STAFF RECOMMENDATION

1535 Douglas Avenue

January 15, 2020

Application: New Construction—Addition; Partial Demolition
District: Eastwood Neighborhood Conservation Zoning Overlay
Council District: 06
Base Zoning: R6
Map and Parcel Number: 07214022800
Applicant: Cheyenne Smith
Project Lead: Melissa Baldock, melissa.baldock@nashville.gov

Figure 2 (left) shows the rear porch to be removed. Figure 3 (right) is the 1957 Sanborn map showing the porch.

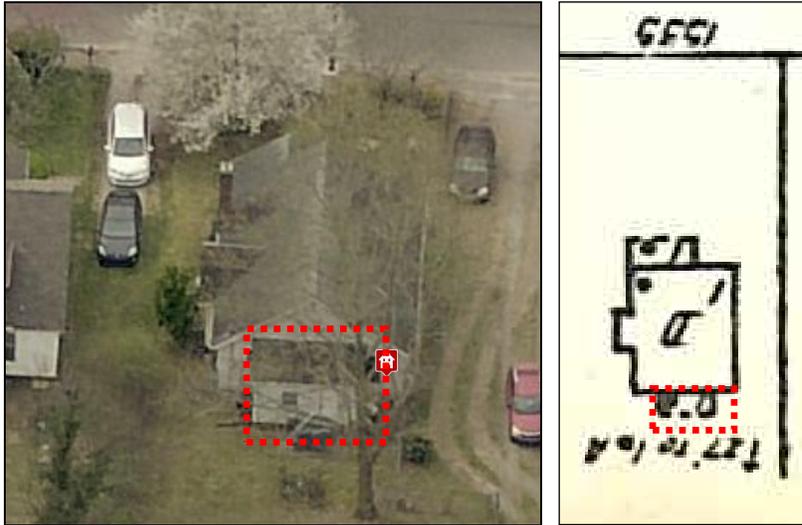
Partial Demolition: The applicant intends to demolish an existing rear portion which may be the same porch seen on the 1957 Sanborn Map (Figures 2 & 3). The porch is now enclosed. Although possibly an old part of the house, small, enclosed rear porches like these with separate roof forms are not an historically significant part of the house. These enclosed porches were often poorly constructed and enclosed and were not meant to last for nearly one hundred years. This one in particular cannot be seen from the street. Staff

finds that its removal will not affect the architectural or historic integrity of the historic house.

Staff finds that the removal of the rear enclosed porch meets Section III.B.2. of the design guidelines.

EXTERIOR
 ELEVATIONS

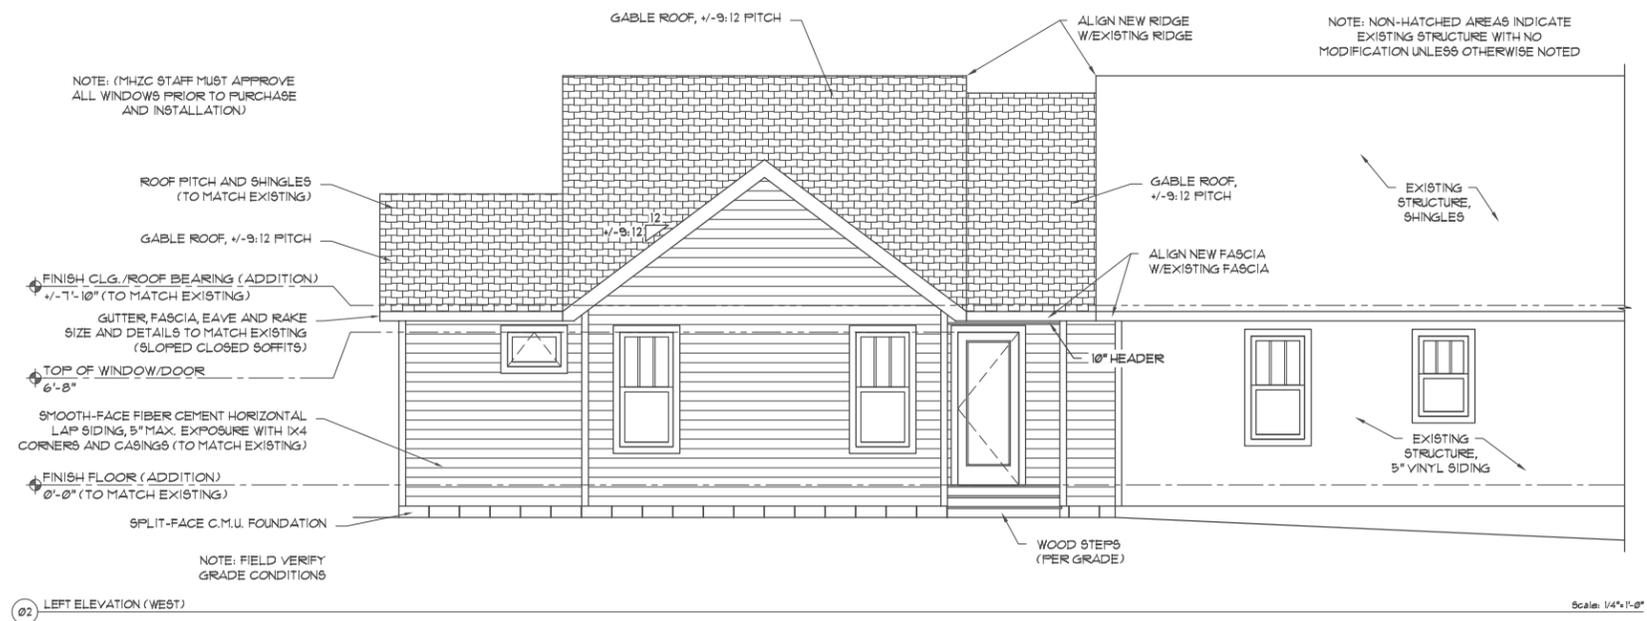
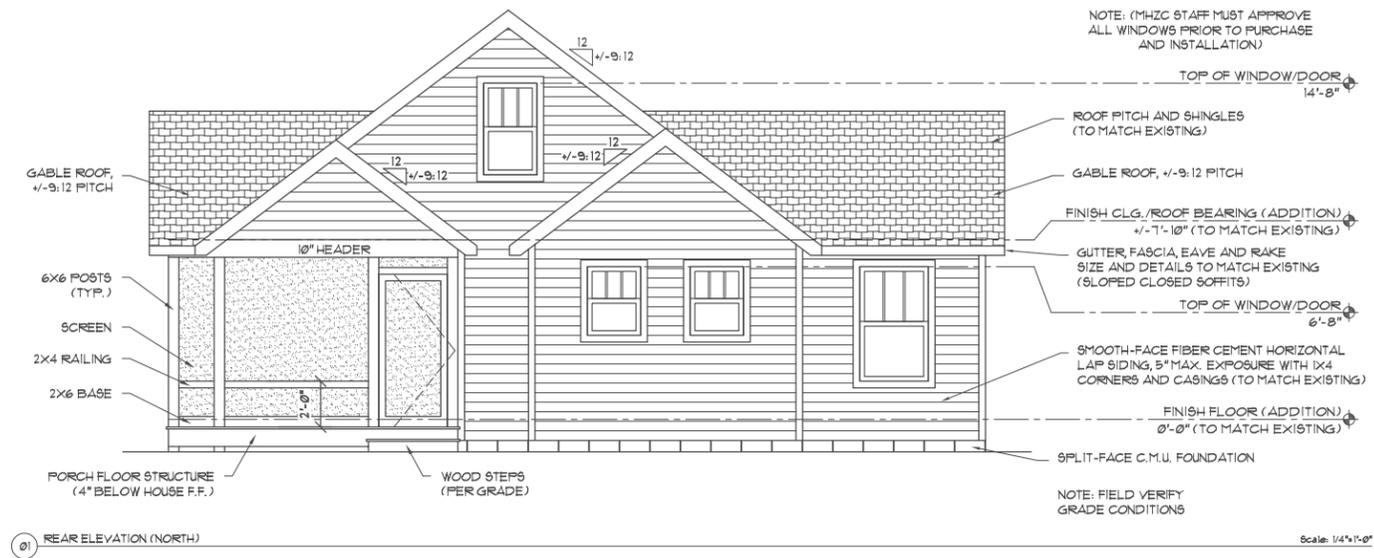
Roof form: The historic house has a front-facing gable with a pitch of approximately 9/12. The proposed addition will tie into the historic house with a front-facing gable at a point approximately nine inches (9”) below the historic house’s roof. The addition contains several gabled roof forms, all with slopes of approximately 9/12 to match the slope of the historic house’s gable.

Proportion and Rhythm of Openings: No changes to the window and door openings on the existing house were indicated on the plans. The windows on the proposed addition are all generally twice as tall as they are wide, thereby meeting the historic proportions of openings. There is one horizontal window opening on the left façade at the back. Because the wall where this window is located is inset eight feet (8’) from the wider portion of the addition, this window will not be visible from the street and is therefore appropriate. There are no large expanses of wall space without a window or door opening.

Staff finds the project’s proportion and rhythm of openings to meet Sections II.B.1.g. and II.B.2. of the design guidelines.
